RE: Marina Bay Residential – Quincy, MA
Special Permit – Structural Peer Review Responses
Mc/Sal Project N: 12145.00

Att: 'Executive Summary' – Excerpt from *Marina Bay Structural Site Peer Review*, Odeh Engineers, October 16,
2012
SO.1 – Structural Basis of Design

Project:	MARINA BAY - RESIDENTIAL QUINCY MA	Project Number:	
Dwg Name:	NORTH BUILDING SECTION	Date:	2012 11 20
Dwg No.:	S0.1	Scale:	N.T.S.
		By:	M.A.W.

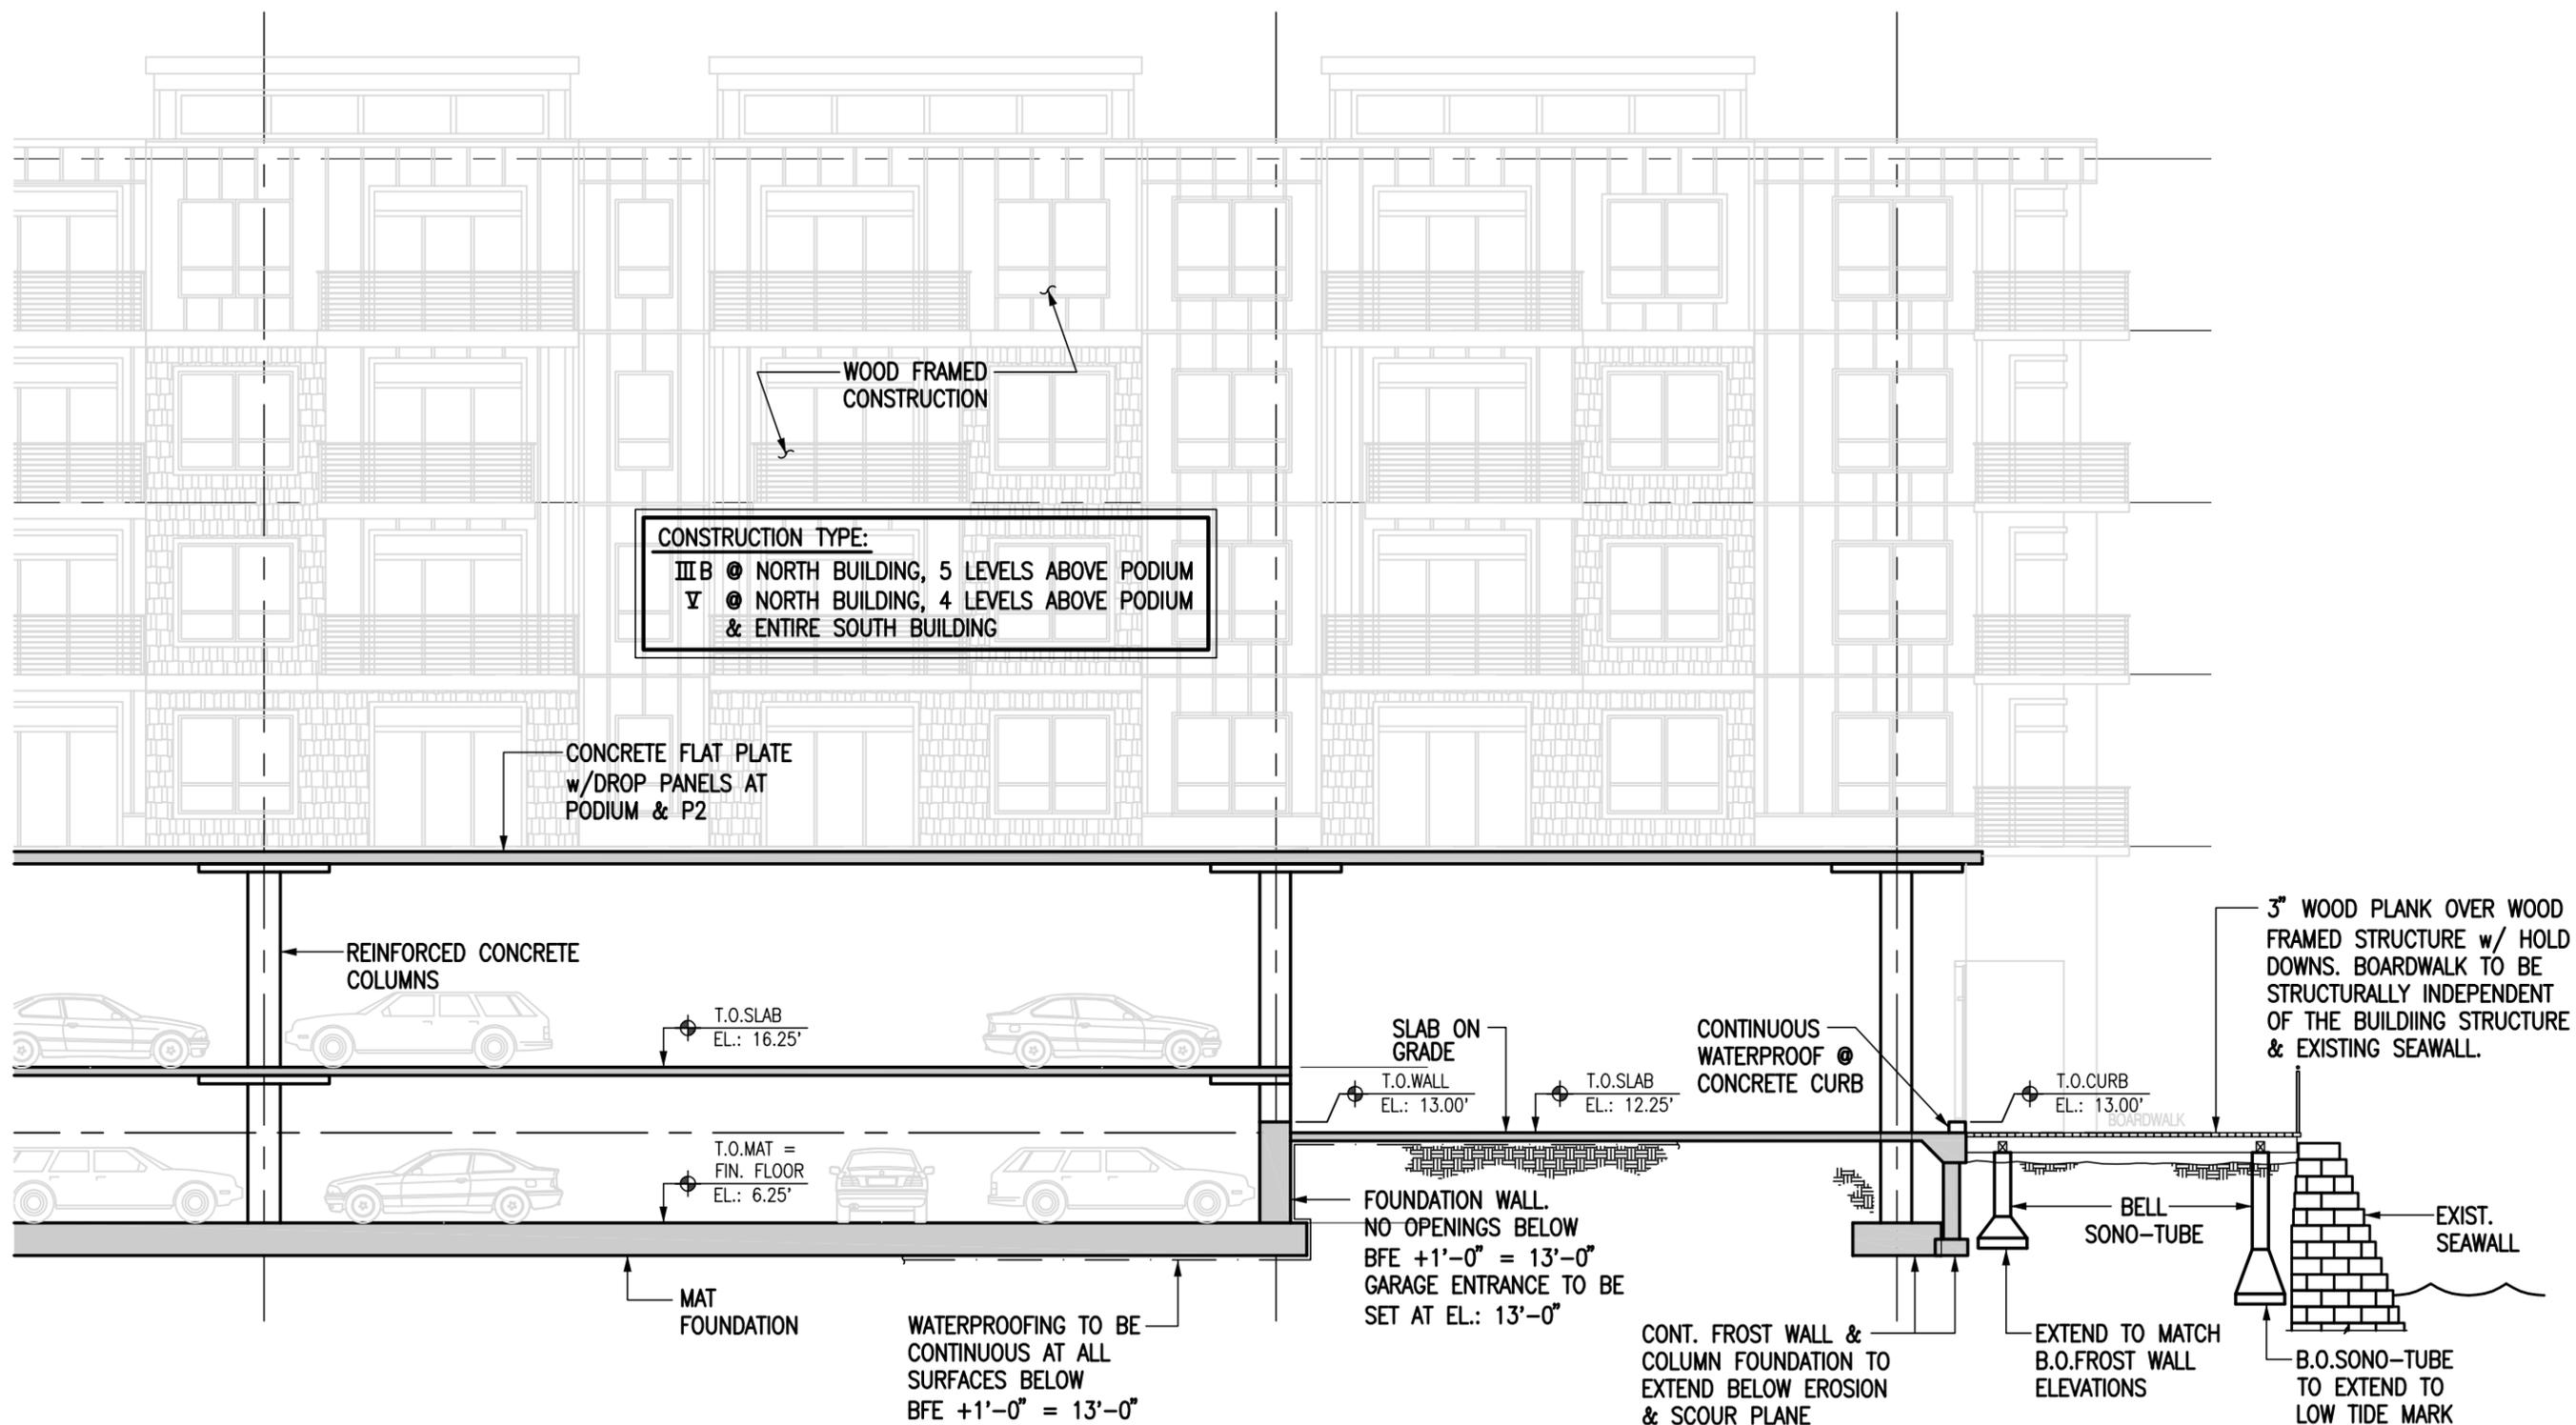
- A. The bottom of the lowest supporting horizontal structural member of the lowest floor for the North Building must be above El. 13 ft in the AE zones and El. 15 ft in AE zones per ASCE 24, Table 4-1. Currently, the lowest floor of the North Building is set at -5'-6" (El. 5.75 ft), the ground level is set at 0'-0" (El. 11.25 ft), and Parking Level 2 (P2) is set at 4'-0" (El. 15.25 ft). Based upon these requirements, no floor areas at Ground Level can be framed. Any framing for Level P2 must be set such that the bottom of framing is above the DFE for the applicable flood zone.

- B. Several areas the North Building at ground level appear to be set on slabs-on-grade, which will most likely be set upon structural fill (aka slabs-on-fill). The Ground Level 0'-0" (El. 11.25 ft) appears to be set upon slabs-on-fill. The local building official could be contacted for direction on this issue. All Grade Level floor areas within AE and VE zones may be required to be framed such that the bottom of the lowest horizontal member is set at or above the DFE.

- C. The uses of the lowest level areas are limited to parking, building access, or storage. This includes areas at Ground Level 0'-0" (El. 11.25 ft.) which are located within AE and VE zones. All walls enclosing areas below the DFE in Zone VE must be designed as breakaway walls. All walls enclosing areas below the DFE in Zone AE must be designed as breakaway walls shall be designed as breakaway walls with flood openings to allow for the automatic entry and exit of floodwaters.

- A. The building footprint and finished floor elevations have been modified. Please reference revised Special Permit Documents as prepared by Elkus | Manfredi Architects. In general, the building has been re-sited to remove the Northwest corner from the VE zone and finished floor elevations have been increased by 1-foot throughout. Level P2, now set at Elevation 16.25', is 3.25' above the DFE for the AE zone. The Level P2 structure is intended to be concrete, flat plate. The bottom of structure will be well above the DFE for the AE zone.

- B. The retail space is intended to be founded on a soil supported slab-on-grade. The structural fill will be confined within a perimeter frost wall on all sides that will extend below the erosion and scour plane and otherwise protect the integrity of the subgrade support. Finished floor elevation has been revised to 12.25', with average grade/boardwalk raised to match. The small amount of exposed foundation wall between grade and the BFE (El. 12') will be designed to resist breaking wave loading in accordance with ASCE 7-05, Section 5.4.4. The slab and walls will be designed for the hydrostatic pressure associated with the DFE (El. 13') in accordance with ASCE 7-05, Section 5.4.2.

- C. The P1 level is set at El. 6.25' and is limited to parking, access, and storage. The top of the ramp at the garage is set at the DFE (El. 13'). The average grade/boardwalk has been revised to elevation 12.25'. The structural design intent is to keep water out of the below grade garage by designing the structure as waterproofed tub. No openings shall exist below the DFE. The foundation and foundation walls will be designed to resist the hydrostatic pressure associated with the DFE and in accordance with ASCE 7-05, Section 5.4.4. Any exposed foundation wall below the BFE (El. 12') will also be designed to resist breaking wave loading in accordance with ASCE 7-05, Section 5.4.4. The foundation walls are necessary to support the surrounding soil. With average grade being within a foot of the DFE, breakaway walls do not significantly relieve the loads imposed to the structure as water needs to almost reach the design elevation before the building begins to flood and equalize pressure. Adding breakaway walls would also compromise the integrity of the foundation wall and pose a greater risk to personal property. For this condition, adding breakaway walls adds more risk than it mitigates. Designing the water tight, structural tub is in effect raising the building out of the DFE.
